DETAILED ACTION

【図 7】

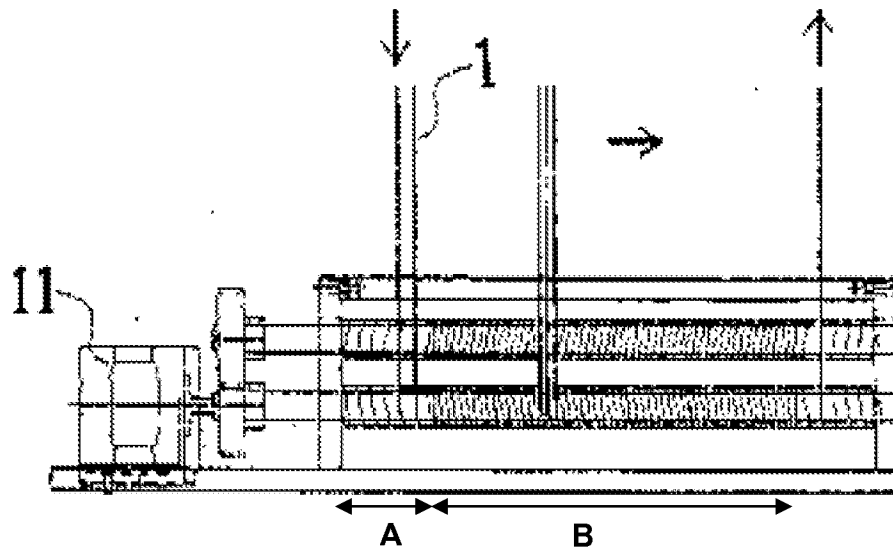
4. **Claims 1 & 2** are rejected under 35 U.S.C. 102(b) as being anticipated by Aoki et al. (JP Pub No. 2000235741; Machine Translation).

Consider claims 1 and 2. Aoki et al. teach: a conveying means, which is a transfer means, for transferring optical disks and a cooling process, which is a cooling device as it is part of the device as disclosed; and two or more feed screws for simultaneous rotation to support and place optical disks, whereby there is a changing screw pitch along the feed screws (¶'s [0001], [0002], [0005], [0007] & [0009]). Aoki et al. further teach: the feed screw shaft having a first region portion (A) positioned at a carrying-in side of disk substrates and a second region portion (B) positioned at a side of carrying-out of disk substrates, and a pitch of the threads formed on the first region portion (A) is larger than a pitch of the threads formed on the second region portion (B) (see figure below).

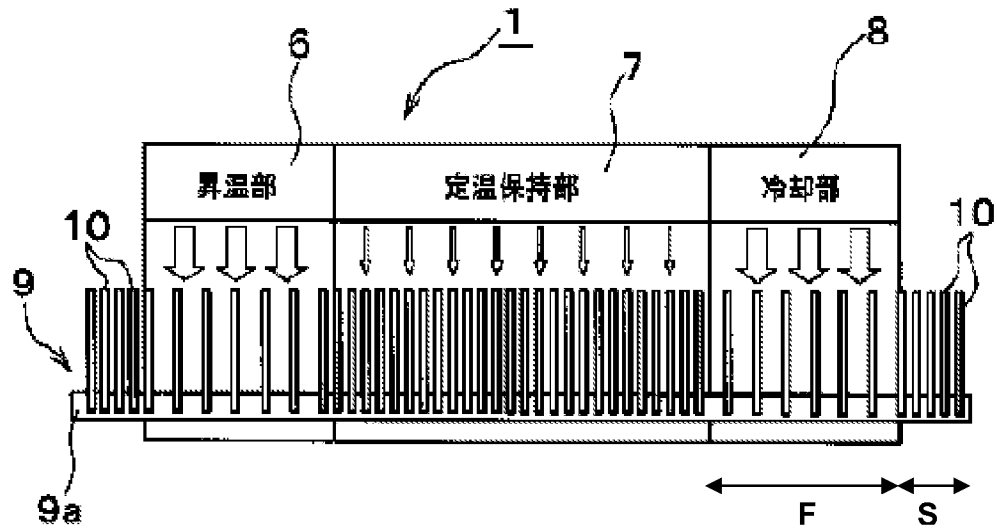
Consider claims 1,2 and 4. Inatani et al. teach shafts, 9a, 9b and 9c, for transfer with a slot spirally formed, which is a transfer means with a feed screw shaft, driven for rotation, which is synchronous rotation since they rotate together, to support and place disk substrates that stand (10) at a plurality of points (¶'s [0014], [0017] & [0018]). The pitch of threads formed on the feed screw shaft differs according to axial positions of the threads such that there is a first region portion (F) and a second region portion (S), where the pitch of the threads is greater on the first region portion (F) than the second region portion

(S). Inatani et al. further teach that the first region portion (F) is longer than the second region portion (S) (see figure below).

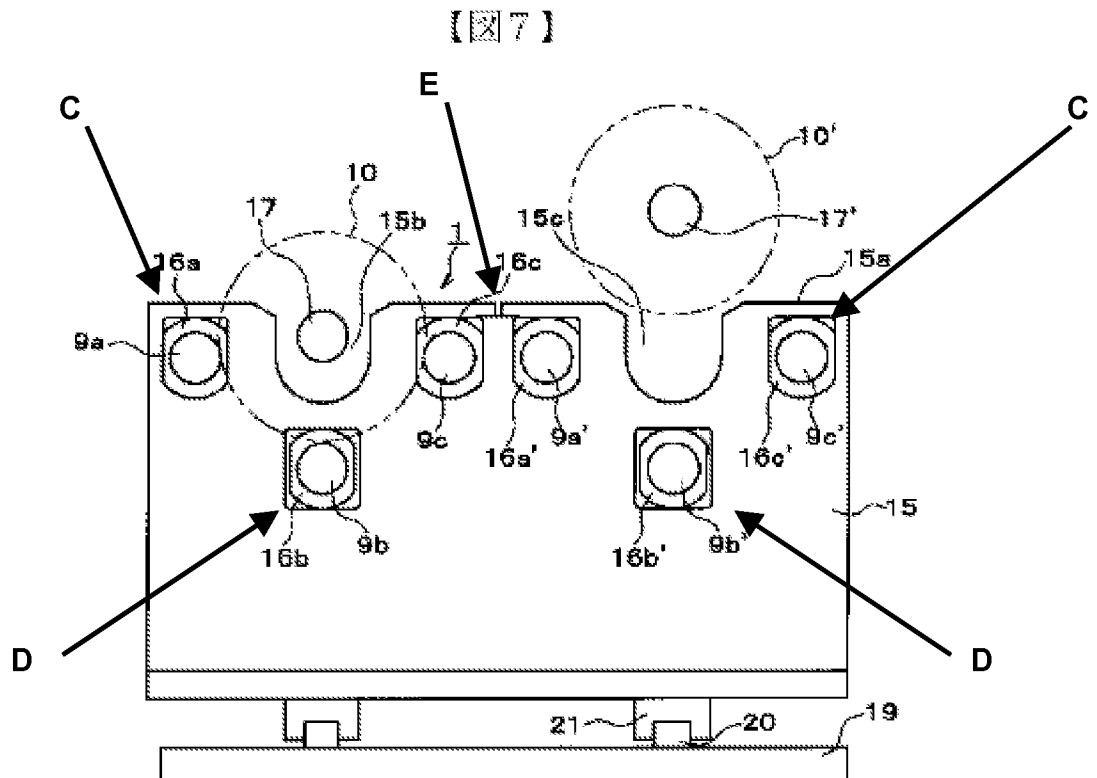
Consider claim 7. Inatani et al. teach that the disks are supported at three points, C, D and E, one of which, (E), is shared by and adjacent disk. Point E is the point between feed screw shafts 9c and 9a' as indicated (see figure below).

FIG. 1

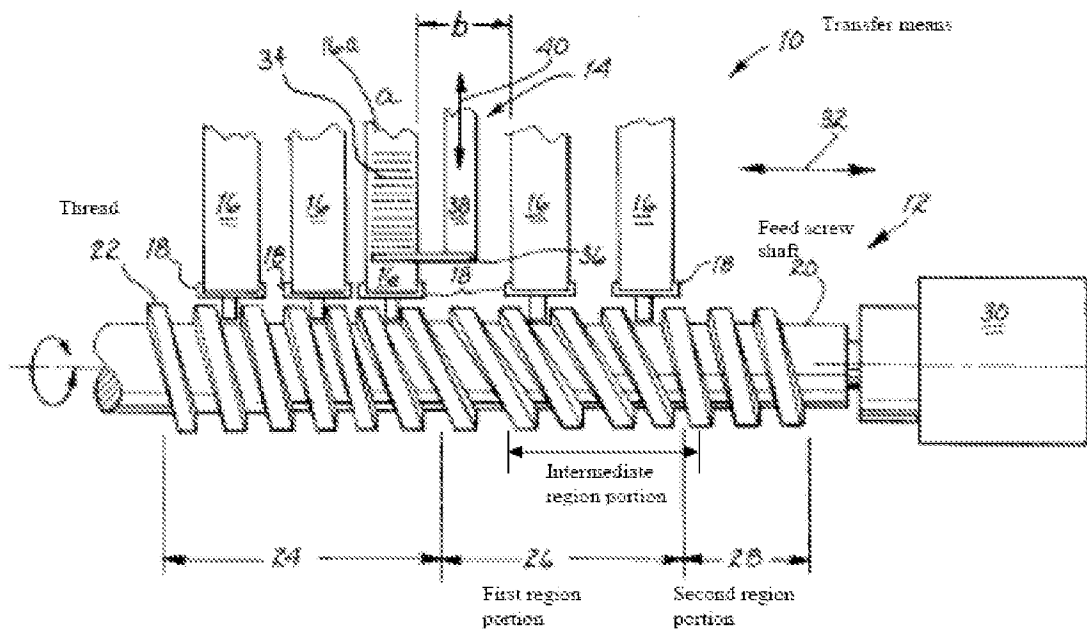
Fierkens teaches: a threaded shaft (20), which is a feed screw shaft, where the pitch of the thread (22) formed on the feed screw shaft (20) differs according to axial positions of the threads (col. 4, L 56-57; col. 5, L23-24 & 38; Fig. 1).

Consider claim 2. Fierkens discloses: the feed screw shaft (20) having a third segment threaded portion (26), which is a first region portion, and a second segment threaded portion (28), which is a second region portion; and a second pitch, which is the pitch of the threads formed on the first region portion (26),

being larger than a first pitch, which is the pitch of the threads formed on the second region portion (28) (col. 5, L 38-44; Fig. 1)

Consider claim 3. Fierkens discloses: an intermediate region (see Fig. 1) portion whose pitch gradually decreases from the first region portion (26) to the second region portion (28), provided between the first region portion and the second region portion (Fig. 1).

Consider claim 4. Fierkens discloses the first region portion (26) being longer than the second region portion (28) (Fig. 1).

FIG. 3

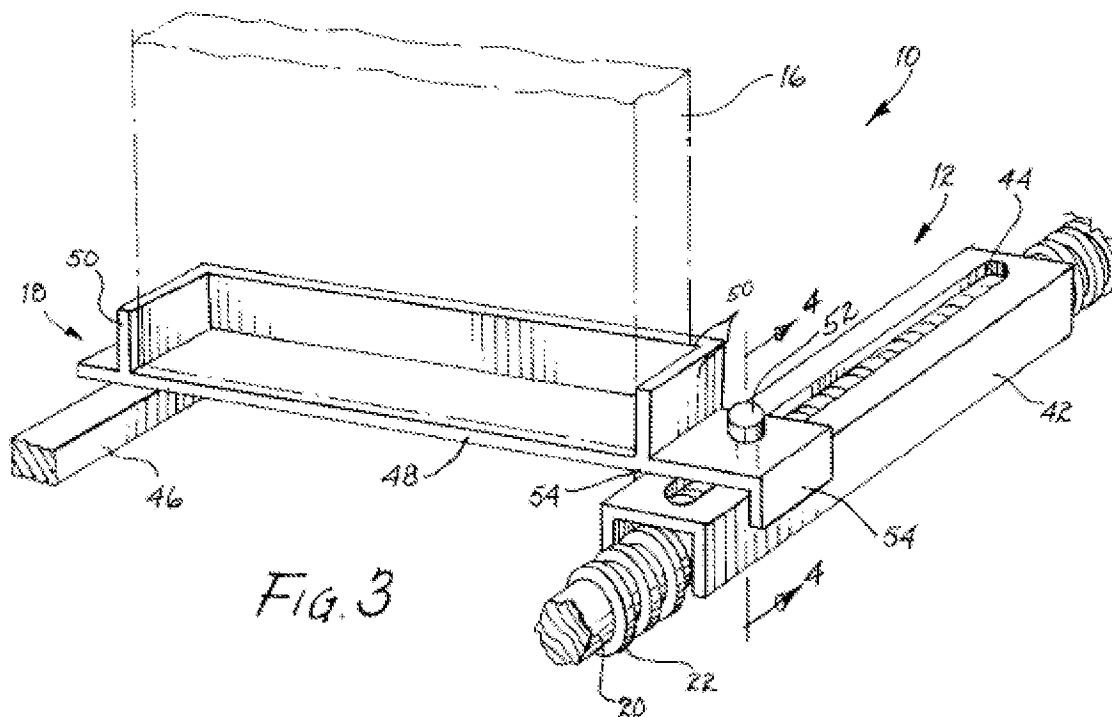
Consider claim 1. Kitano et al. disclose a cooling conveyor (22) comprising first (22a) and a second (22b) cooling conveyors, which are transfer means for transferring optical disk substrates in a standing state (col. 5, L 7-8 & 15-17; Figs. 1-3)

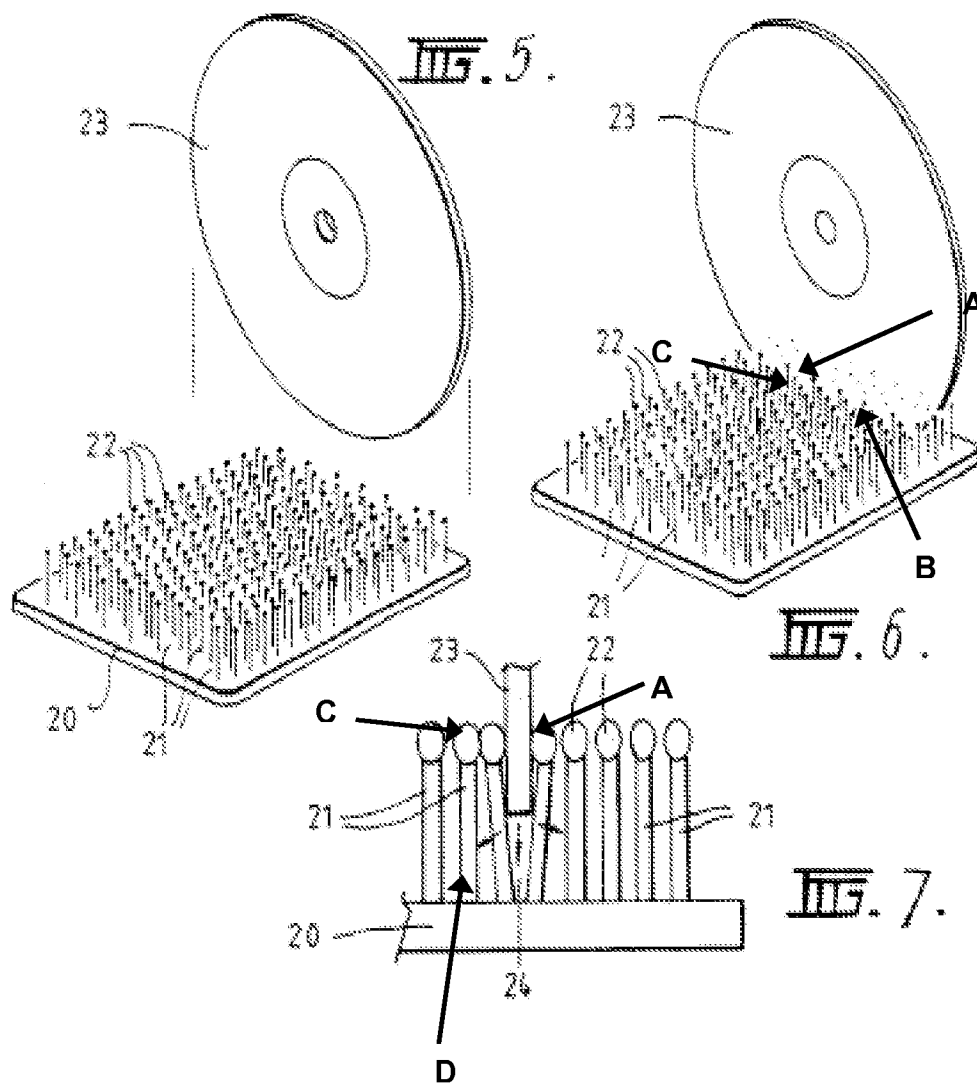
Kitano et al. as modified above fail to disclose the disks supported at three points, one of which is shared by an adjacent disk.

Cooke teaches a holding means for retaining disks (23) to support the disks at three points, (A), (B) and (C), with one of the points, (C), shared by an adjacent disk in space (D) (See Figs. 5 – 7 below). The holding means is adapted to hold a plurality of articles, which are disks in this case (col. 2, L 27-28).

Since Cooke teaches that the holding means may hold a plurality of articles such as disks, if a disk were inserted into space (D), the newly inserted

disk would share point (C) with disk (23) in supporting both disks. It would have been obvious to one of ordinary skill in the art at the time of the invention to modify the transfer means disclosed by Kitano et al. as modified above with the holding means taught by Cooke in order to provide a reliable and compact supporting mechanism for the disks to be vertically oriented as they move through the cooling unit.
